SUBJECT: ROD CLUSTER CONTROL ASSEMBLY FULLY WITHDRAWN POSITION (TAC 71982, 71983) (TS 89-15) - SEQUOYAH NUCLEAR PLANT, UNITS 1 AND 2

TENNESSEE VALLEY AUTHORITY
DOCKET NO. 50-327
SEQUOYAH NUCLEAR PLANT, UNIT 1
AMENDMENT TO FACILITY OPERATING LICENSE

TENNESSEE VALLEY AUTHORITY
DOCKET NO. 50-328
SEQUOYAH NUCLEAR PLANT, UNIT 2
AMENDMENT TO FACILITY OPERATING LICENSE

SAFETY EVALUATION BY THE OFFICE OF NUCLEAR REACTOR REGULATION
SUPPORTING AMENDMENT NO. 108 TO FACILITY OPERATING LICENSE NO. DPR-77
AND AMENDMENT NO. 98 TO FACILITY OPERATING LICENSE NO. DPR-79
TENNESSEE VALLEY AUTHORITY
SEQUOYAH NUCLEAR PLANT, UNITS 1 AND 2
DOCKET NOS. 50-327 AND 50-328

FIGURE 3.1-1

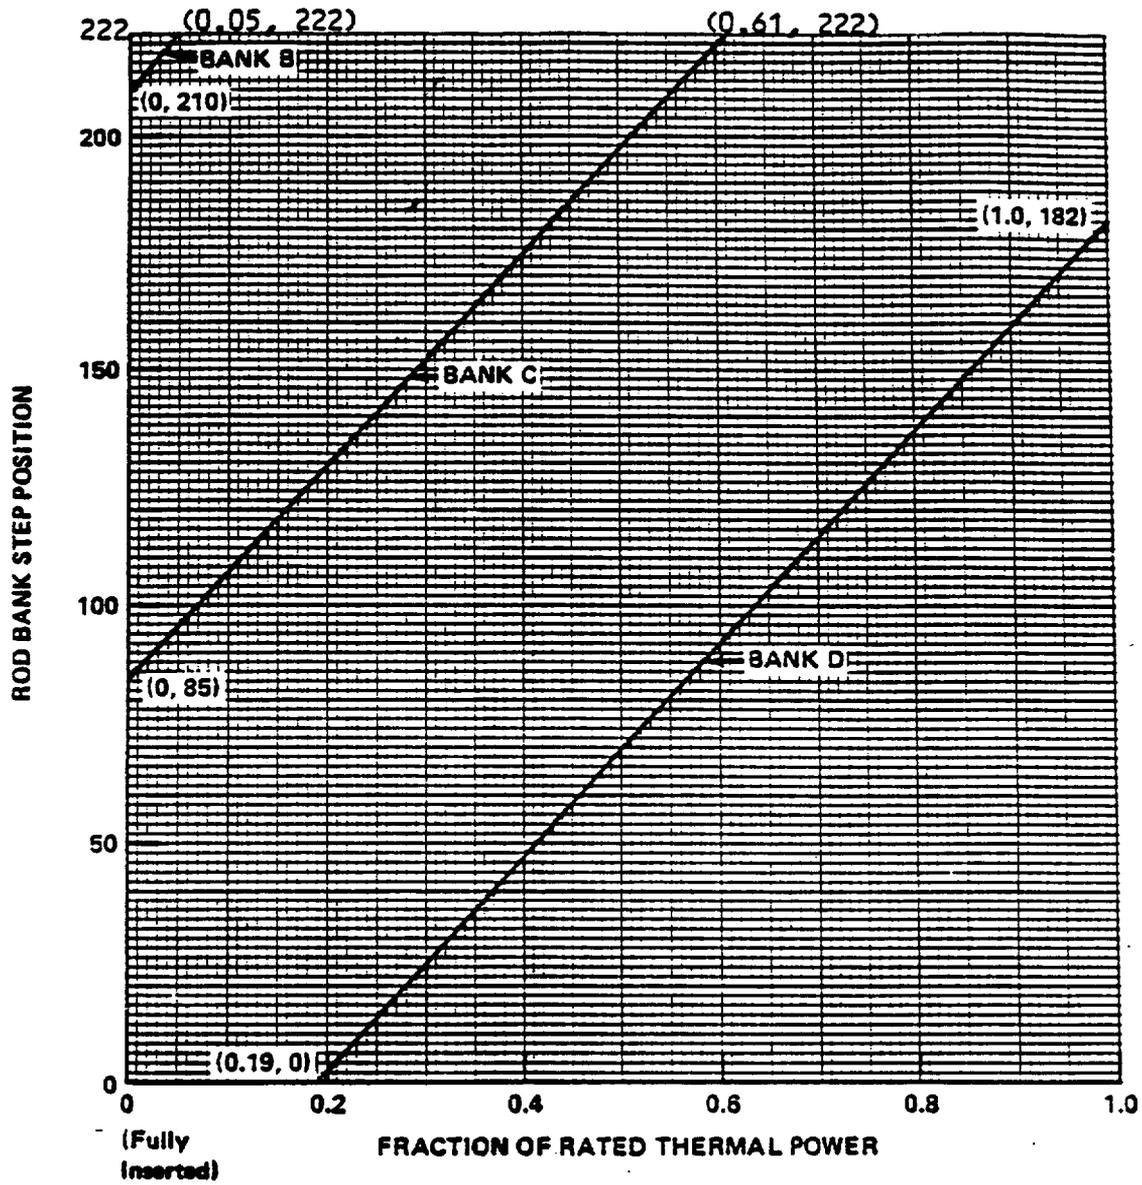
These amendments modify Section 3.1.3, Movable Control Assemblies, of the Sequoyah, Units 1 and 2 Technical Specifications (TS). The changes revise the limiting conditions for operation 3.1.3.4 and 3.1.3.5 and the Figure 3.1-1 to define the fully withdrawn condition for shutdown and control rod banks as a position within the interval of equal to or greater than 222 steps withdrawn and of equal to or less than 231 steps withdrawn. A section is added to the Bases of the TS to define the fully withdrawn condition for the shutdown and control rod banks.

(Fully Withdrawn)*

*See page 3/4 1-23

The term fully withdrawn is applied to shutdown and control banks in TS LCOs 3.1.3.4 and 3.1.3.5. Figure 3.1-1, "Rod Bank Insertion Limits Versus Thermal Power - Four Loop Operation," indicates fully withdrawn is 228 steps. The above proposed change will redefine the term fully withdrawn in LCOs 3.1.3.4 and 3.1.3.5 and modify Figure 3.1-1 to allow axial repositioning of shutdown and control banks within the interval of 222 to 231 steps.

Fully withdrawn shall be the condition where shutdown and control banks are at a position within the interval of ≥ 222 and ≤ 231 steps withdrawn, inclusive.

There are no rod insertion limits when the shutdown and control banks are at a position within the interval ≥ 222 and ≤ 231 steps withdrawn, inclusive. The fully withdrawn position shall be specified in a reload safety evaluation for each cycle of operation and, once specified, shall not be changed unless such a change is specifically evaluated.

FIGURE 3.1-1
ROD BANK INSERTION LIMITS VERSUS THERMAL POWER
FOUR LOOP OPERATION

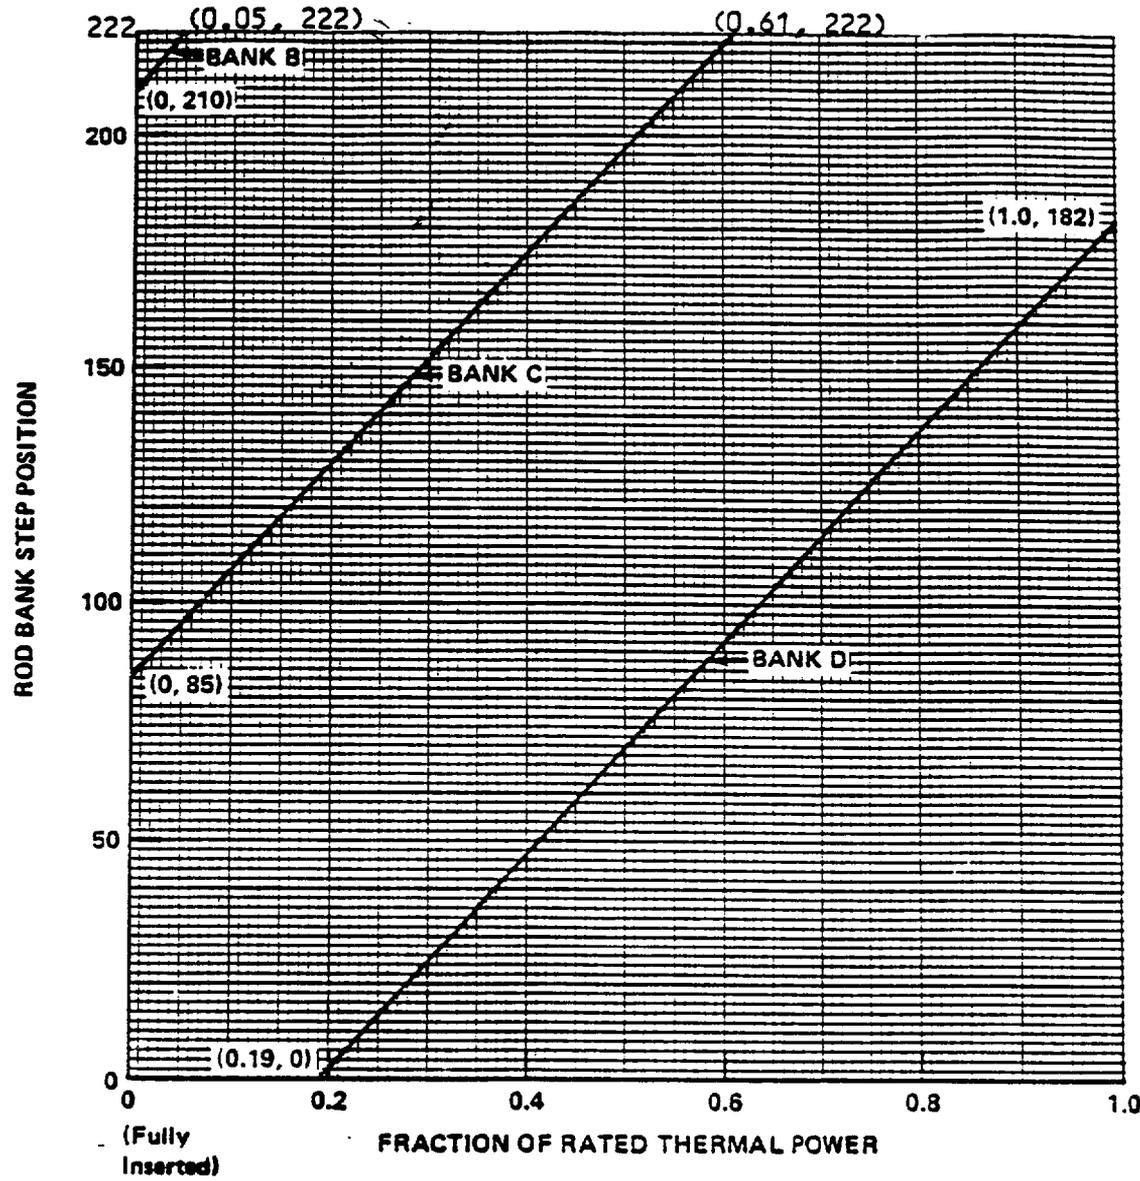
(Fully Withdrawn)*

*See page 3/4 1-23.

Fully withdrawn shall be the condition where shutdown and control banks are at a position within the interval of ≥ 222 and ≤ 231 steps withdrawn, inclusive.

There are no rod insertion limits when the shutdown and control banks are at a position within the interval > 222 and < 231 steps withdrawn, inclusive. The fully withdrawn position shall be specified in a reload safety evaluation for each cycle of operation and, once specified, shall not be changed unless such a change is specifically evaluated.
